The Rose of East Des Moines, LP - 1331 Idaho Street

21-2006-4.17

CONCEPTUAL PLAN FOR ROSE OF EAST DES MOINES, A PLANNED UNIT DEVELOPMENT  
IN THE CITY OF DES MOINES, POLK COUNTY, IOWA, SHEET 1 OF 4

## CONCEPTUAL PLAN FOR ROSE OF EAST DES MOINES, A PLANNED UNIT DEVELOPMENT

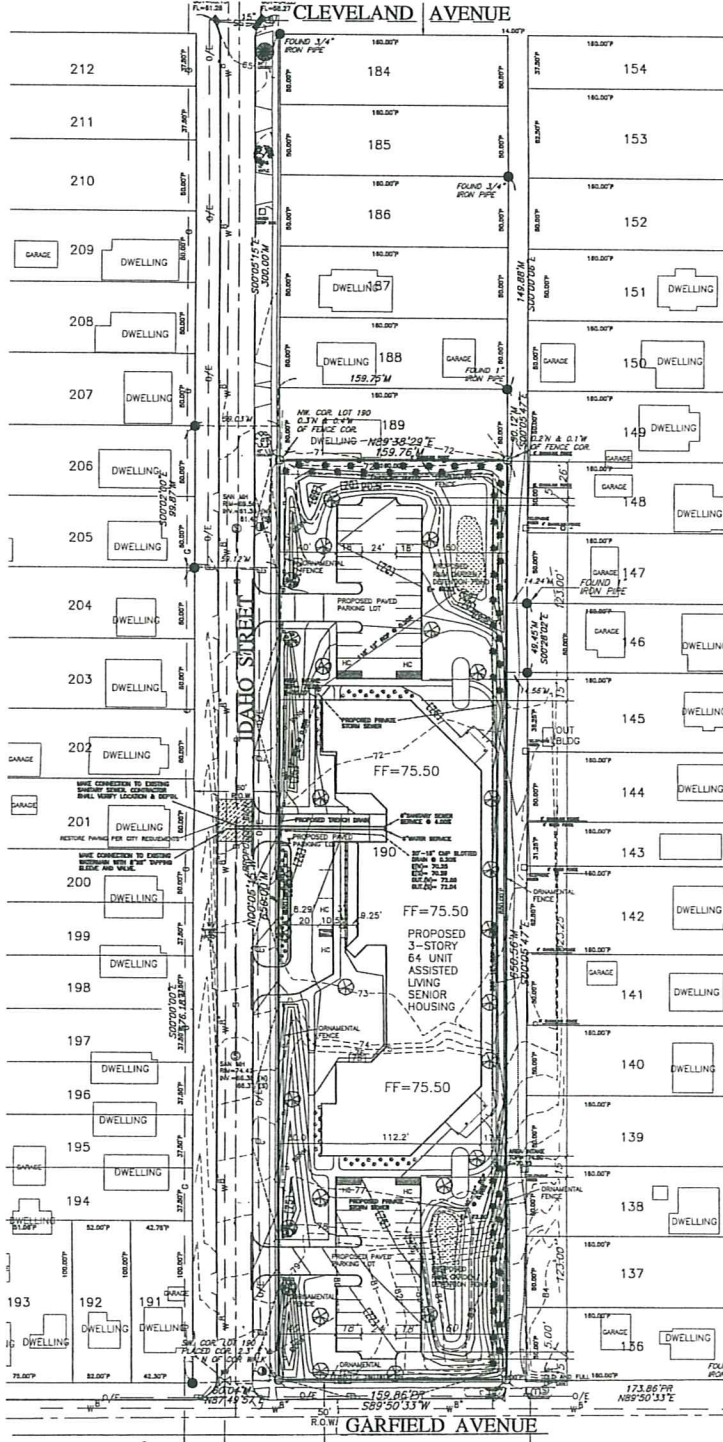
Part C) Staff recommends denial of the requested rezoning from "R-2A" General Residential District to "PUD" Planned Unit Development District on the basis that the proposed 64-unit, 3-story structure setback 12.6' from the east property line would be out of character with the low-density residential character of the neighborhood.

The adjoining north/south alley is currently utilized by at least three of the residential properties that are oriented toward East 15<sup>th</sup> Street. The submitted Conceptual Plan requires the traveled path of this alley to be realigned so that it is located entirely within the right-of-way, as a portion of the graveled alley passes over the fringe the of the subject property.

The building would be setback 35' from the west front property line adjoining Idaho Street and 158' from the south front property line adjoining Garfield Street. The building would be setback 12.6' from the east property line adjoining the north/south alley and 169' from the north property line adjoining a single-family dwelling. Staff believes that the proposed rear yard setback is inadequate as the *R-3 zoning district would require a 35' rear yard setback and the R-4 zoning district would require a 30' rear yard setback.*

*Staff believes that the building mass of the proposed structure is not compatible with the existing architectural character of the surrounding area, as the proposed 3-*

story structure would predominantly be surrounded on three sides by 1-story, single-family dwellings. The proposed building would be 323'-long with a 225'-long segment being within 12.6' from the east property line.

*The proposed 3-story building with a maximum height of 40' is not proportional to the mass and scale of the surrounding single-family dwellings on the same block. The west facade is articulated, setback, and subdivided but the east facade is relatively flat and unbroken. The impact of this facade is intensified due to its placement 12.6' from the east property line. The R-3 zoning district would require a 35' rear yard setback and the R-4 zoning district would require a 30' rear yard setback.*

1. compliance with the revised concept plan and landscape plan showing a minimum of 17.5 foot rear yard setback;
2. use of hardi-plank siding where siding was indicated on the submitted elevations.
